# AGENDA MEETING ST. TAMMANY PARISH BOARD OF ADJUSTMENT MEETING MARCH 7, 2022 2PM

# ST. TAMMANY PARISH BOARD OF ADJUSTMENT STAFF ANALYSIS REPORT

Case File Number: BOA Case No. 2023-3229-BOA
Initial Hearing Date: 03/07/23
Date of Report: 02/28/23

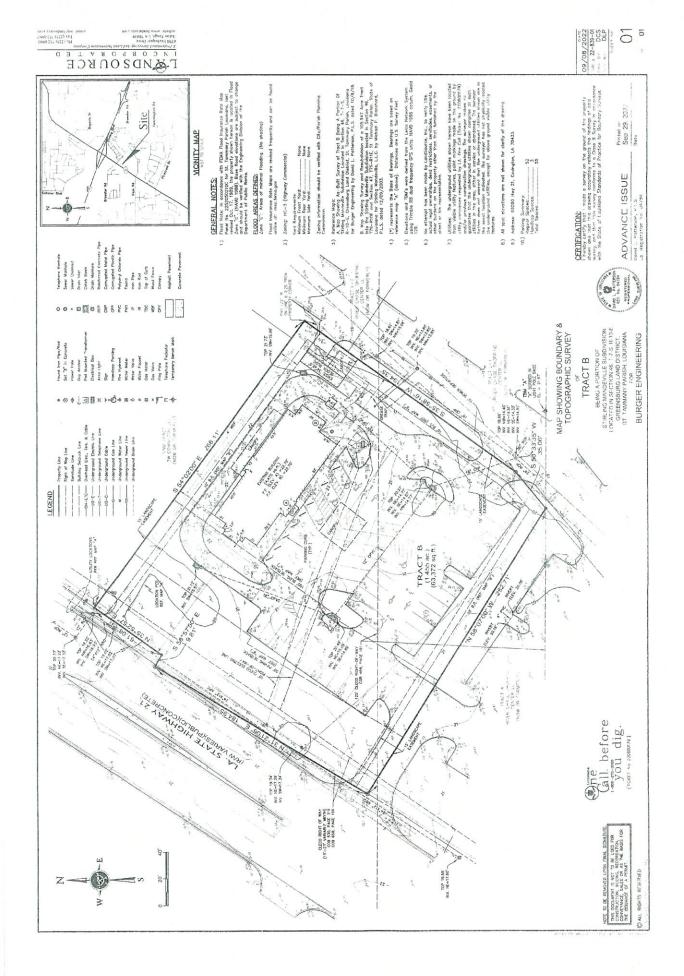
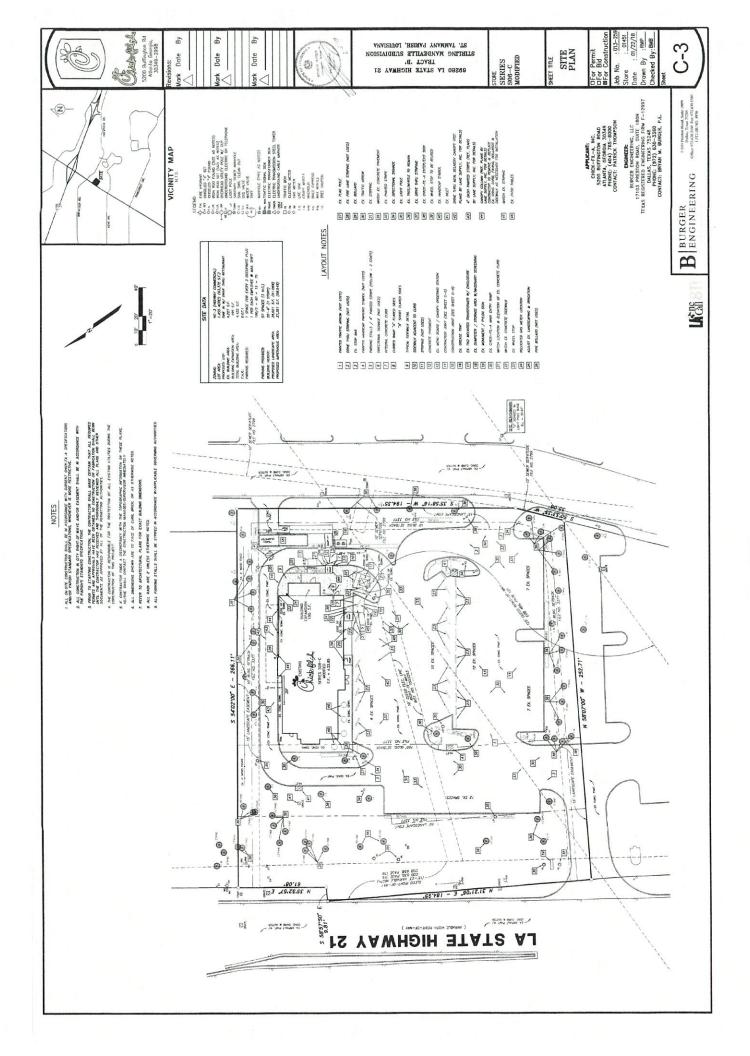
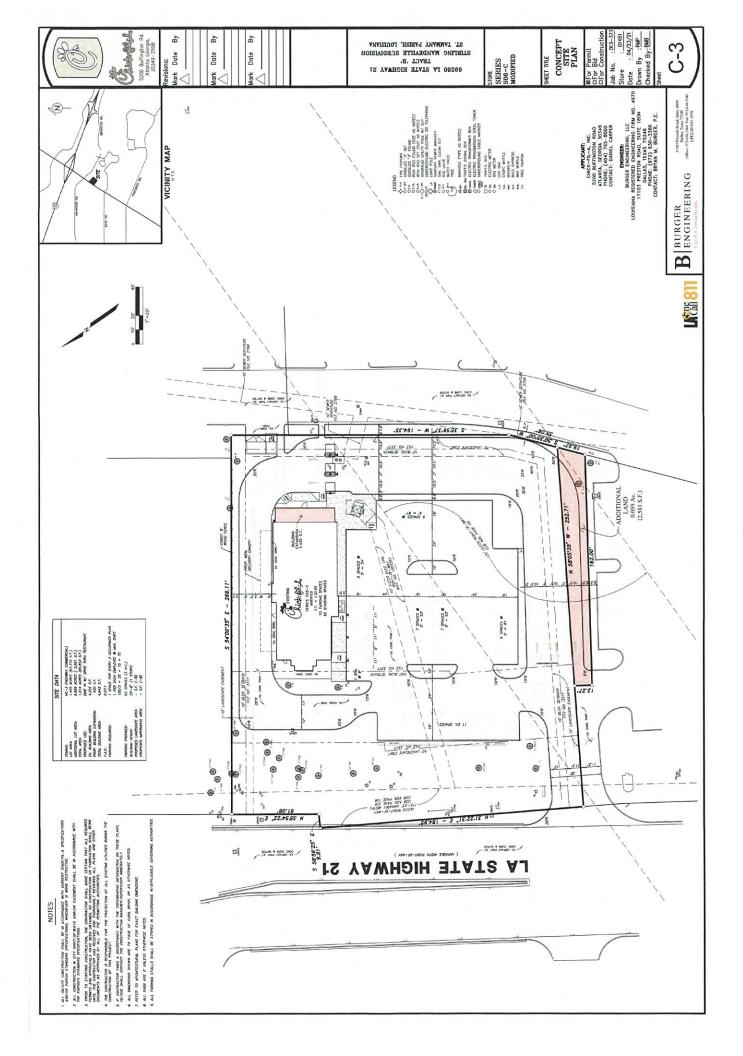
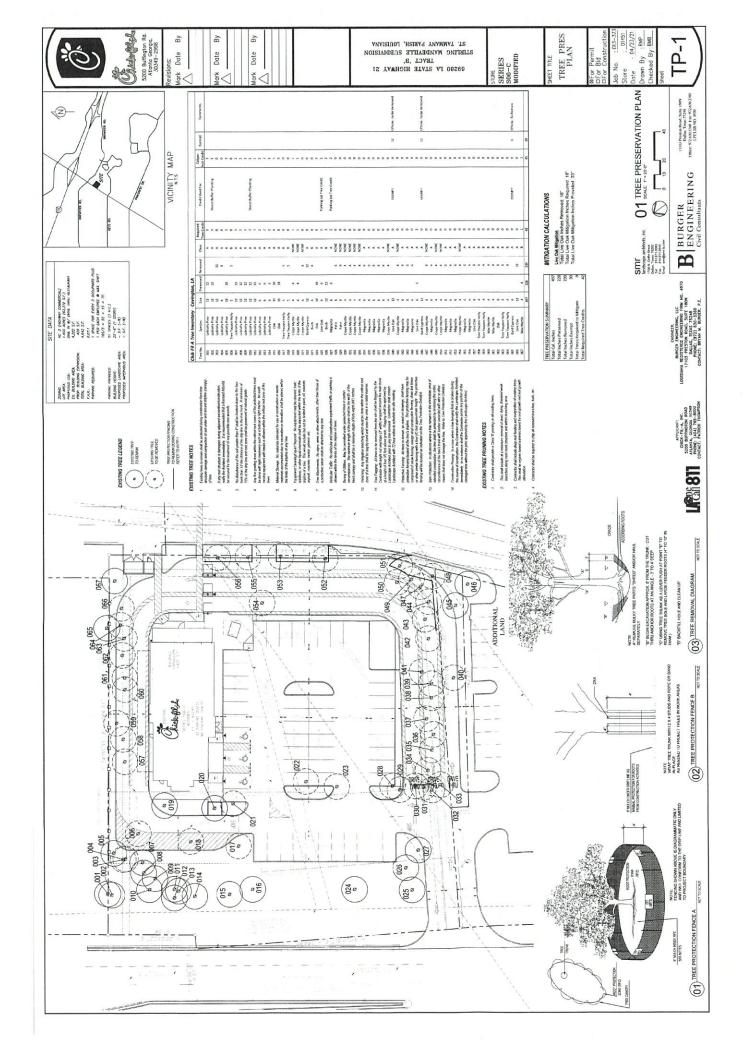
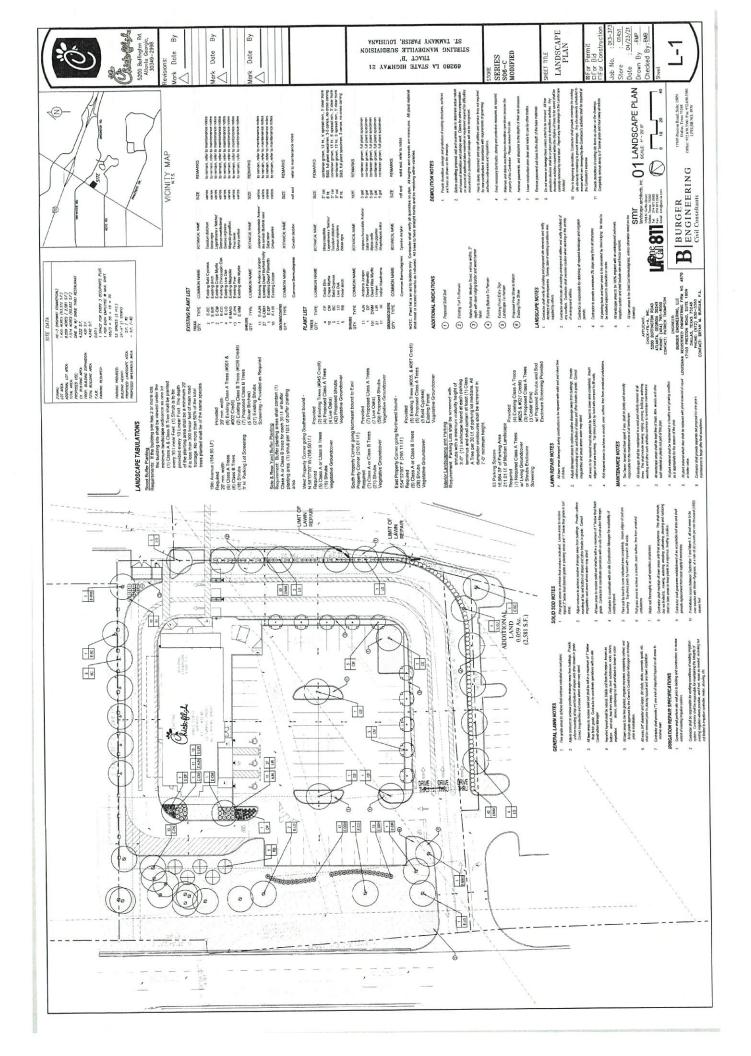
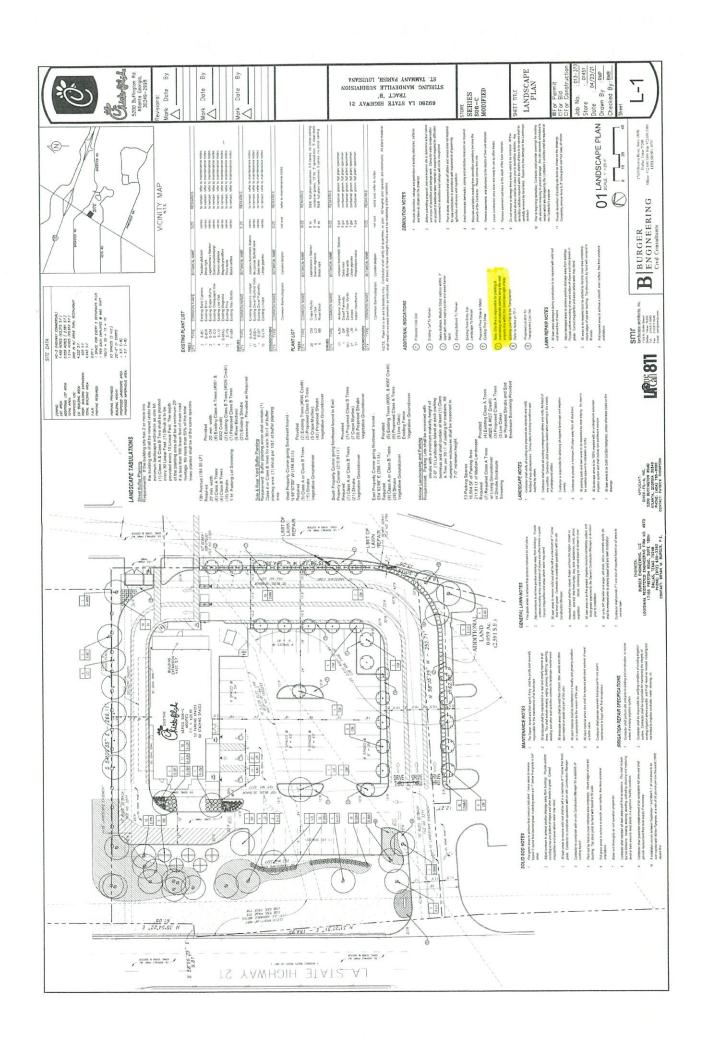
As shown on the attached drawing, the construction of the 3<sup>rd</sup> drive-thru lane would require the removal of a portion of the existing 5 foot buffer on the east side of the property and the removal of existing magnolia & crape myrtle trees. The magnolia trees are proposed to be replaced with 7 Class B trees/Crape Myrtle and shrubs/dwarf wax myrtle, within the abutting River Chase right of way. Note that the objective of the landscaping ordinance is to encourage the preservation of existing trees and buffers.

- 2. The addition of the 3<sup>rd</sup> drive-thru also triggers the request for the removal of:
  - trees within the southern buffer.
  - more than 50% of the existing protected trees (live oaks and cypresses) on the overall site, in conjunction between the previously approved variance to remove cypress and oak trees for the 2<sup>nd</sup> drive thru lane and the current variance request.

Additional trees are proposed to be planted within the existing buffers and the parking area to mitigate the removal of some of the trees. As stated above, the RBCO allows for the removal of live oak and cypress trees and replacement within the Tree Mitigation Areas and elsewhere on the property. As per the tree preservation plan identified as Sheet TP-1 (see attached), one live oak and one cypress are requested to be removed and replaced within the RBCO communal greenspace/Tree mitigation area.

The removal of the existing live oaks and cypress trees do not only defeat the objective of the RBCO, which is to provide for a high quality design, but also the objective of the landscaping ordinance, which is to encourage the preservation of existing trees and buffers.

3. The existing dumpster located on the site will remain in its current location; however, since it will be increased in size, there is a request to reduce the size of the existing 10 foot buffer to accommodate the larger dumpster. There is no objection to the request, since it will not require the removal of any existing trees and additional shrubs are proposed to be planted in the rear of the dumpster.

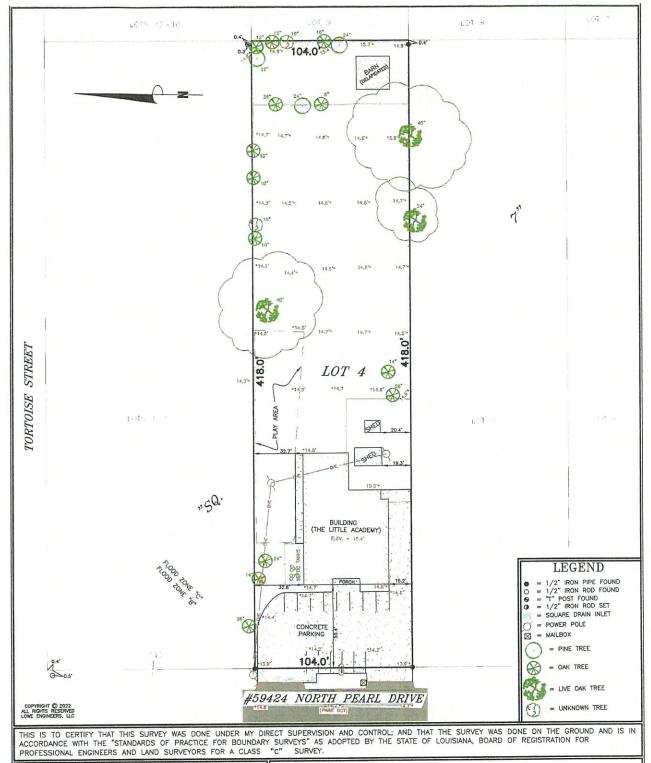
The objective of the requested waivers is to allow for the construction of a new a limestone access drive which will extend approximately half of the property. The new driveway will provide access to a new building and additional parking spaces proposed to be located in the rear of the existing building (see attached plan). While the construction of the new driveway will require the removal of 4 of the existing oak trees, all the live oak trees and other trees located on the property will be preserved. A total of seven (7) parking islands with a Class A trees in each island are proposed to be provided to mitigate the removal of the 4 oak trees. There is no objection to the request considering that the additional trees and parking islands will definitely enhance the appearance of the front parking lot and the entire site.
